## Product Change Notice

Issue Date: 19 June 2015

Introduction of alternate manufacturing site for Chiplid part numbers listed below:

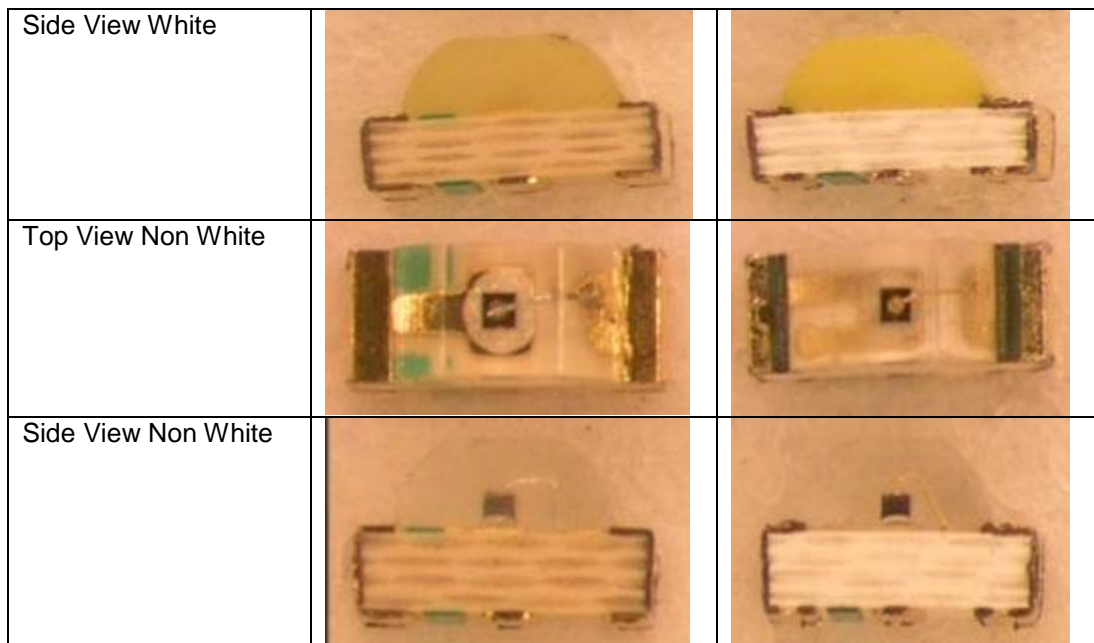
The current and alternate manufacturing site can be identified through the country of origin indicated on the Mother Label and Baby Label. The country of origin printed on the Mother Label and Baby Label for the alternate manufacturing site is China.

Comparison from current and alternate manufacturing side as below:

Parameter	Current Manufacturing side	Alternate Manufacturing side
Top View White

Parameter	Current Manufacturing side	Alternate Manufacturing side
Mother label		
Baby label
